Presentations and Actions for WEC Meeting with NRC June 9 through June 11 - (Non-Proprietary)

Attachment to DCP_NRC_002929

This attachment represents the Westinghouse responses to NRC staff comments from the June 9-11, 2010, meetings in Rockville, Maryland. The staff comments were generated in response to review of the Westinghouse Design Report for the AP1000 Enhanced Shield Building, (APP-1200-S3R-003, Revision 2) from May 2010.

Shield Building Demand vs Capacity

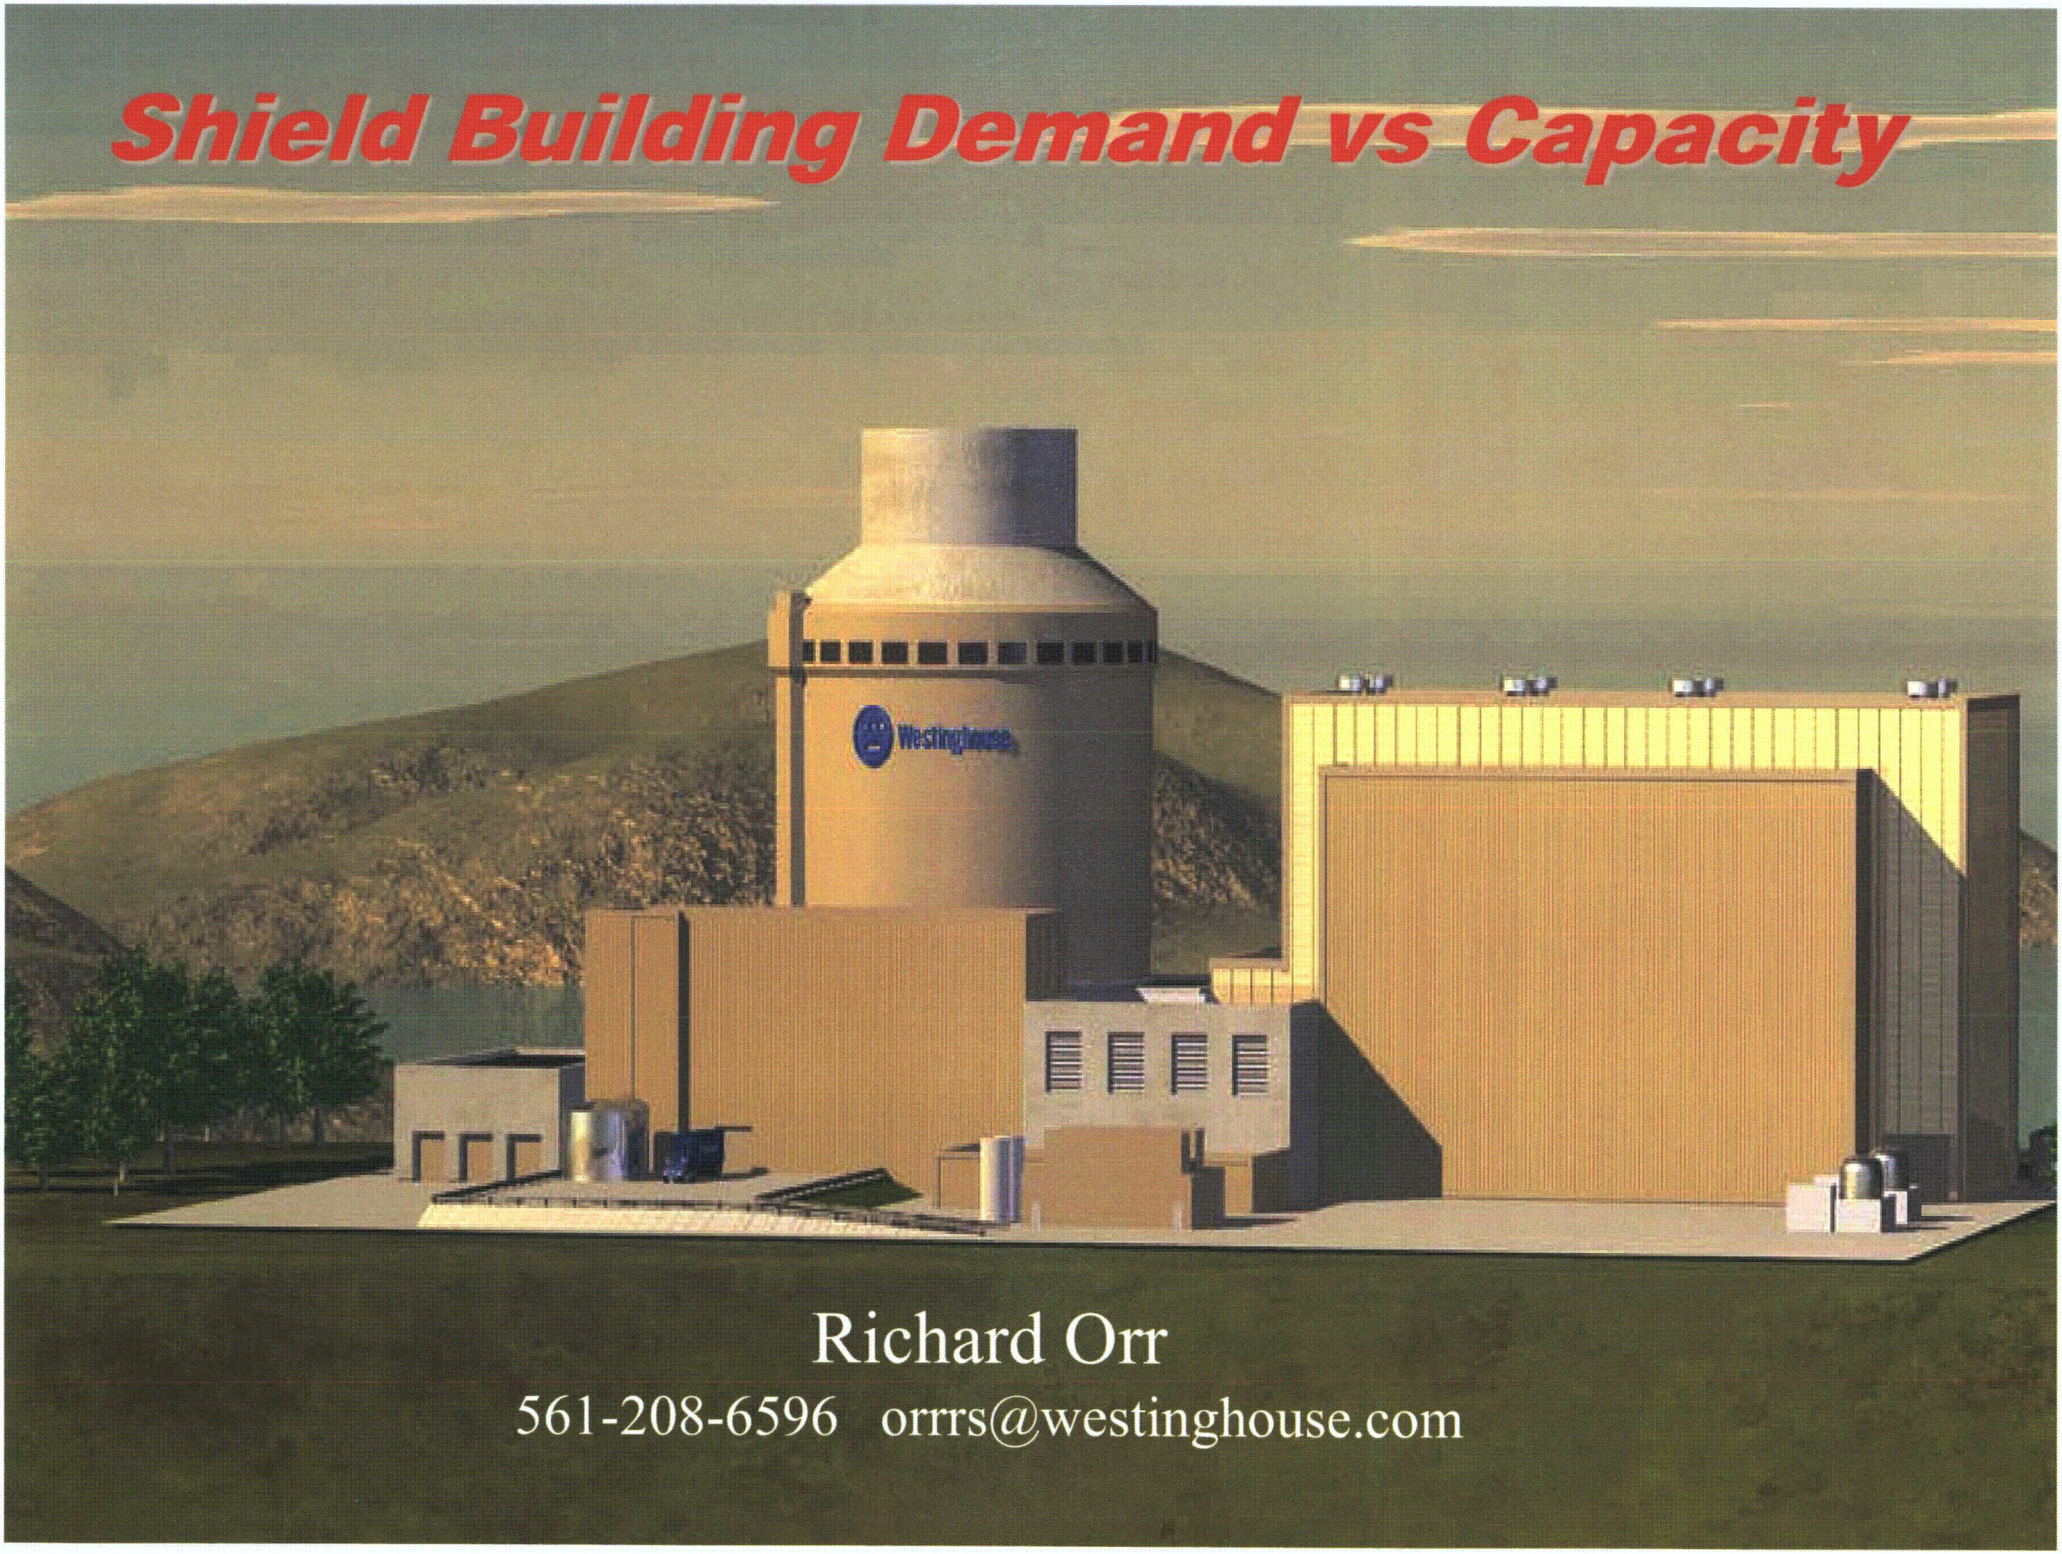
Although Appendix F contains force contours, the plots are insufficient for full understanding of the design demands and related design capacities.

Staff believes that it is necessary to know the magnitude of demands (required bending moment, shear, and torsion), and of the capacity of the member with respect to bending moment, shear, and torsion. This is usually presented by plotting the magnitude of demands and capacities along the entire length of the member. However, these plots are absent in the report.

Provide the calculated demands and capacities in a form that permits the full and ready understanding of the design demands and related design capacities?

For example, provide information, i.e., plots for OOPS (wall, roof, and PCS tank) , in-plane shear (wall), torsion (wall), bending moment (wall, roof, and PCS tank). Also, include plots of capacity with only the steel contribution to the OOPS (SC wall) capacity and identify locations where the steel contribution alone would be insufficient to meet demands.

Westinghouse states that capacity is greater than demand. In Appendix F, WEC shows contour plots of member forces for load combination 6 (for the SC wall).

Maximum Out of Plane Shear in 17" x 17' Tie Region

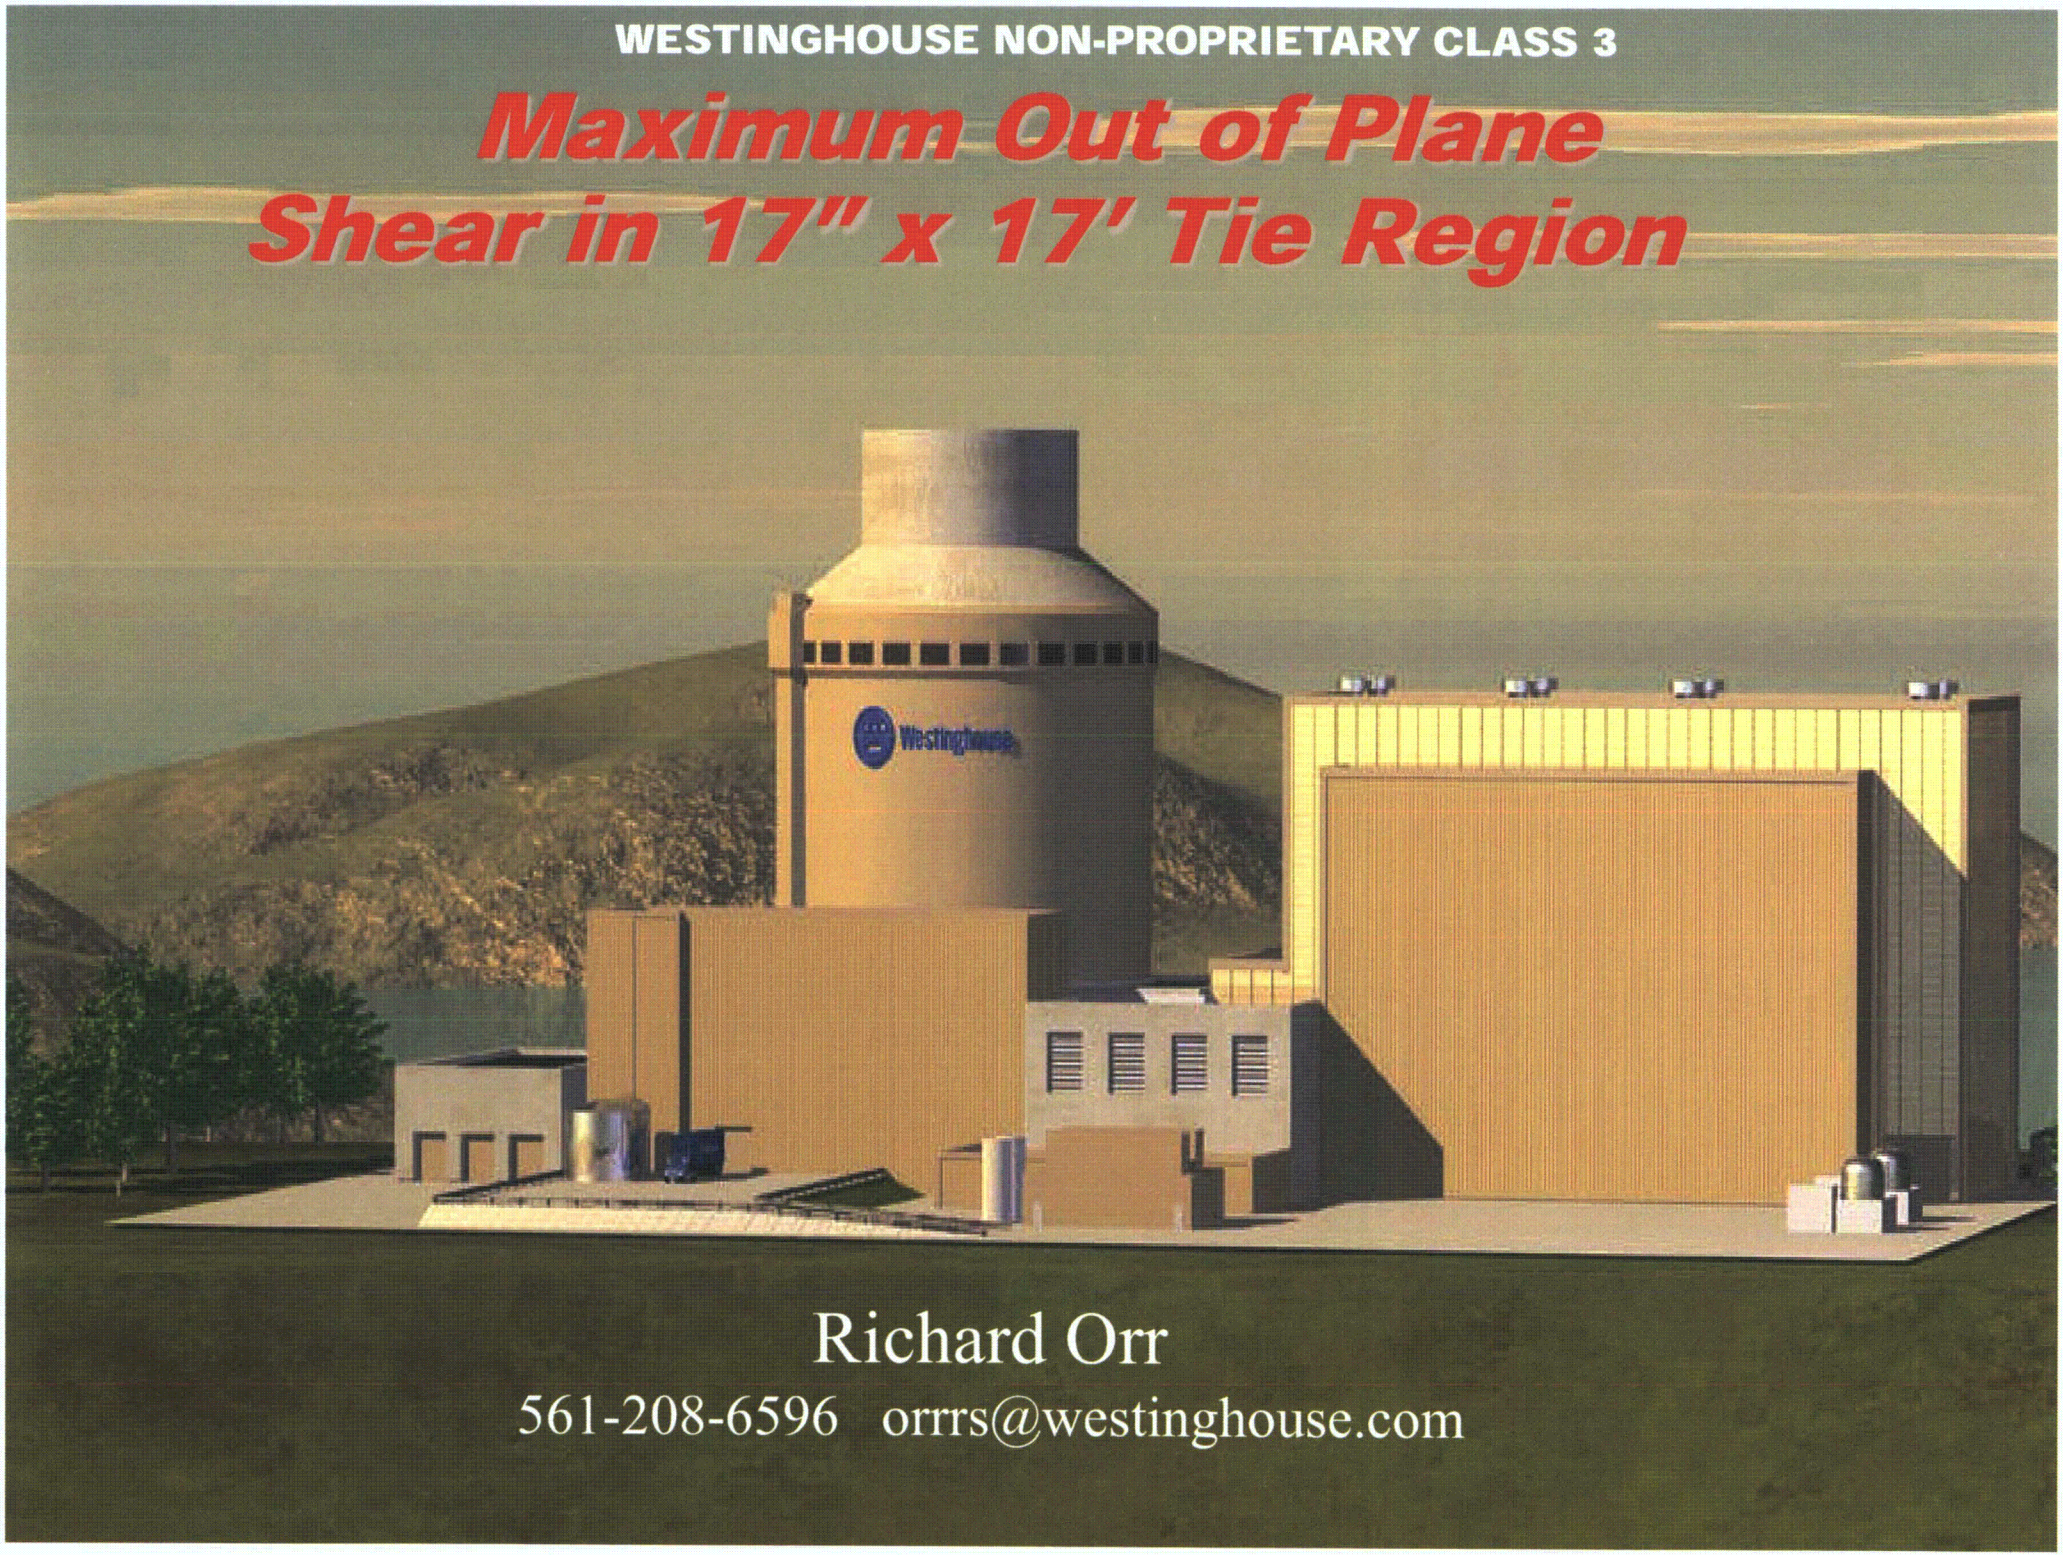
Based on the indicated brittle failure in the OOPS test of the specimen, as provided under Figure 7.7-7 pg. 7-18, and given that Westinghouse indicated that they will demonstrate ductile failure, justify how the resultant brittle failure demonstrates safety in the Shield Building structure

Out-of-plane shear strength is adequately predicted by the test results shown in Figure 7.7-7, p 7-18 and Figure 7.11-16, p 7-110 of the Design Report for the AP1000 Enhanced Shield Building.

Shield Building Benchmarking and System Ductility

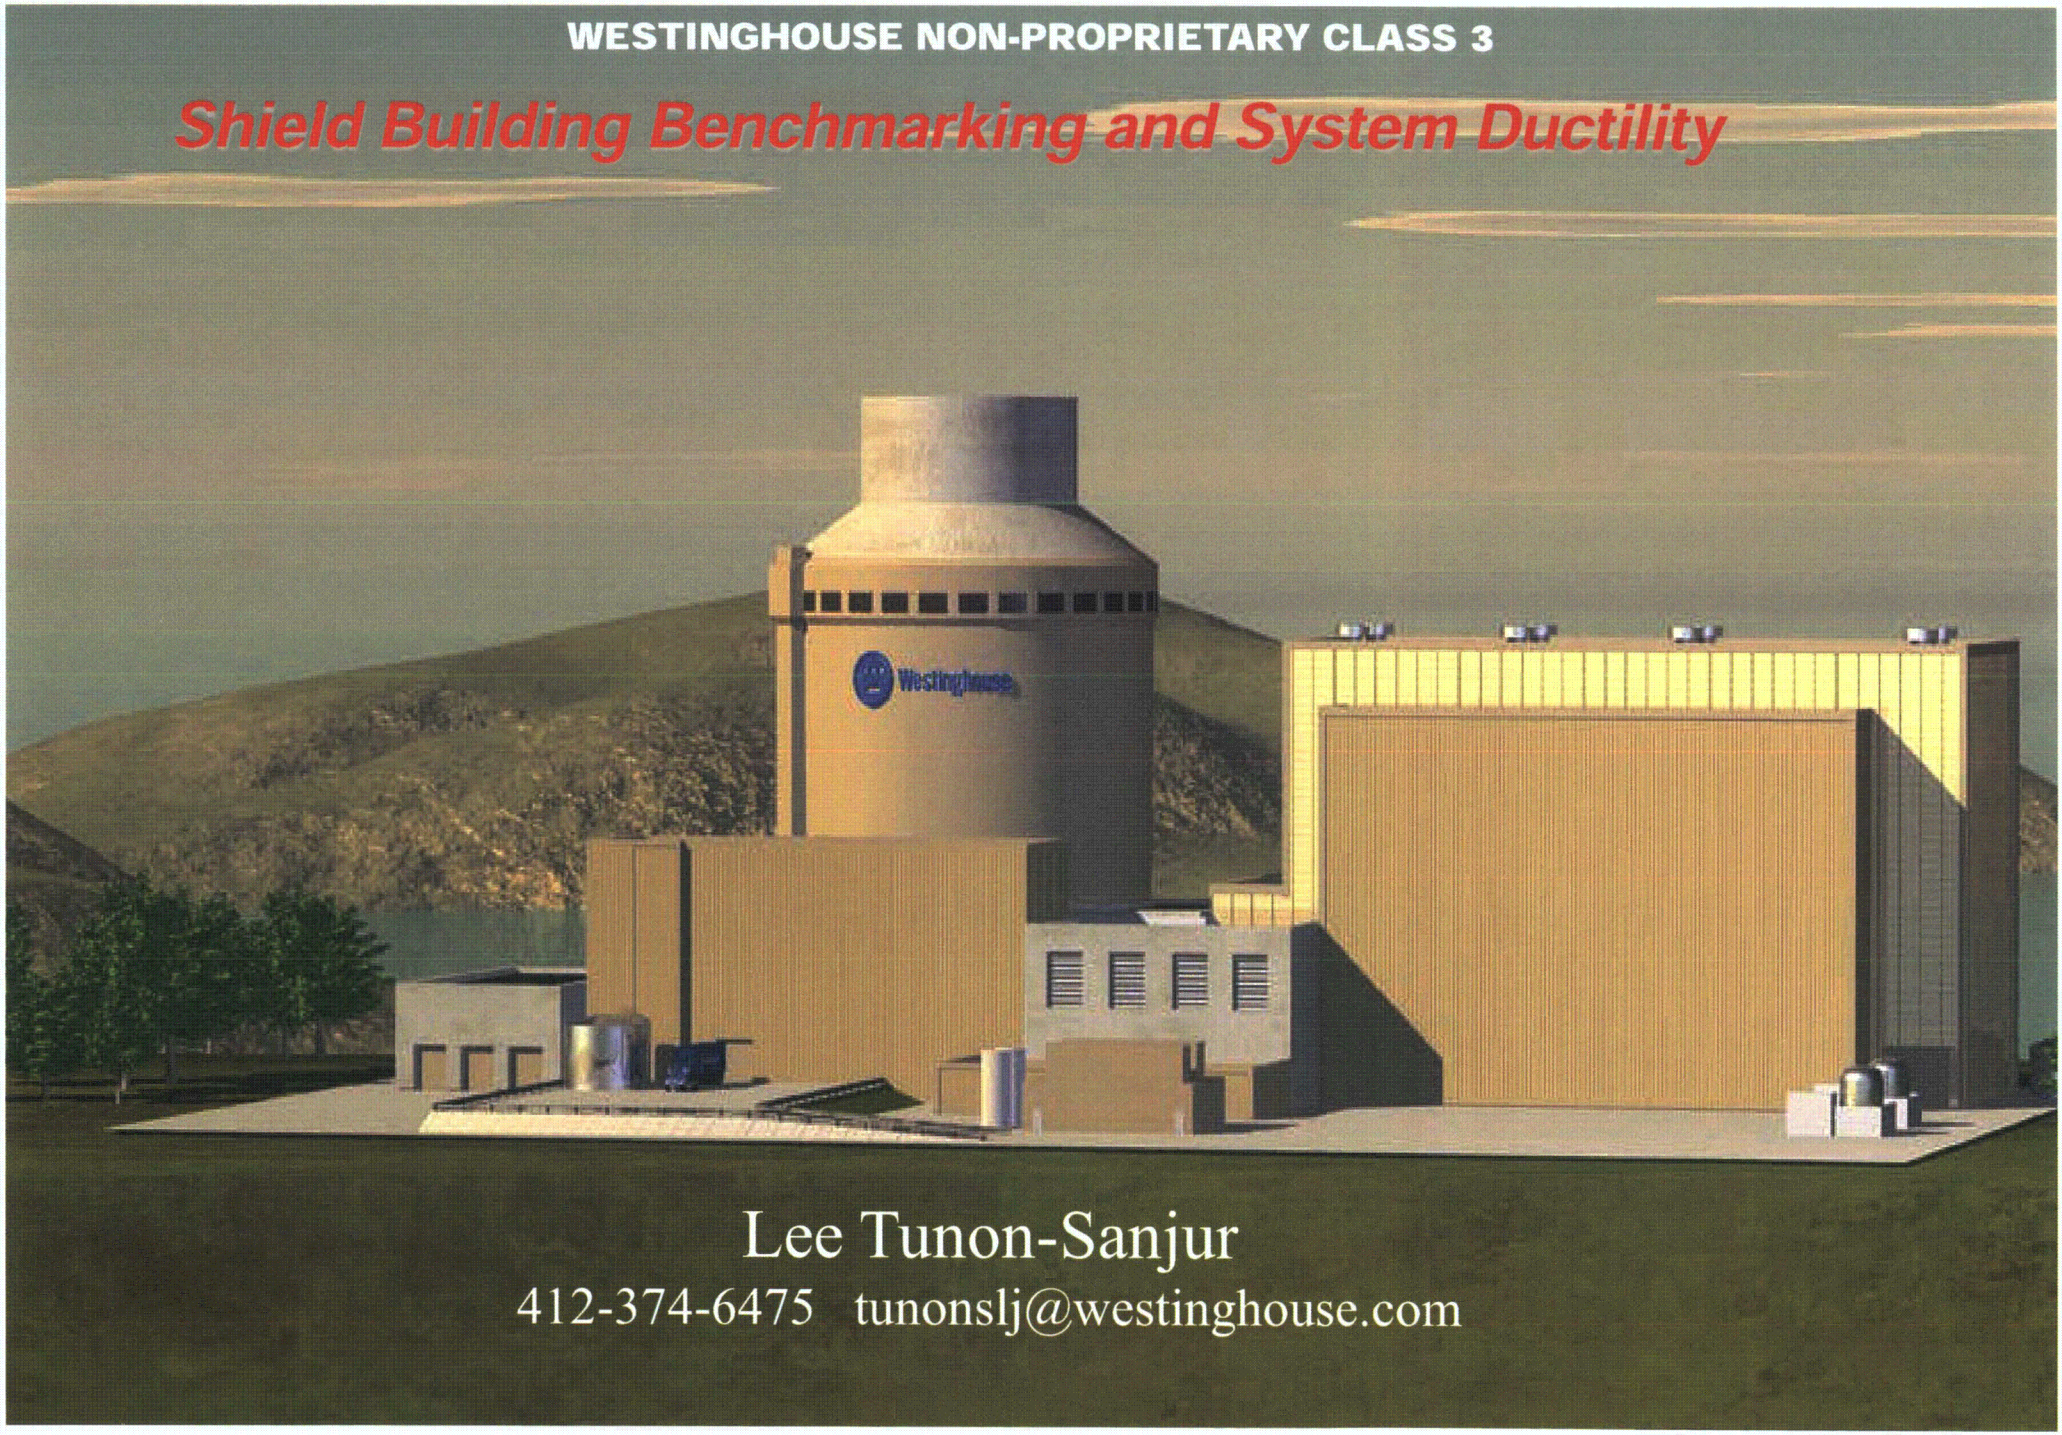
(1) The staff is concerned that all the four concrete models in the [ ]^{a,c} computer code over predicted the ductility of the AP1000 Shield Building SC wall by a significant amount. Therefore, the adequacy of the results is questionable.

(2) The report does not describe how the [ ]^{a,c} code, used for [ ]^{a,c}, was benchmarked to experimental results. Further, the report does not provide any assessment of the mesh size sensitivity for the [ ]^{a,c} model.

(2) Given that the report does not describe how the[ ]a,c code, used for [ ]a,c was benchmarked to experimental results, and does not provide any assessment of the mesh size sensitivity for the [ ]a,c model, how does Westinghouse justify the adequacy of the [ ]a,c

(3) In addition given that the handoff from [ ]a,c would underestimate demands if the [ ]a,c is too stiff, how does Westinghouse verify adequacy of the handoff procedure that was used?

Westinghouse will provide the benchmarking of the [ ][a,c] model to the staff.
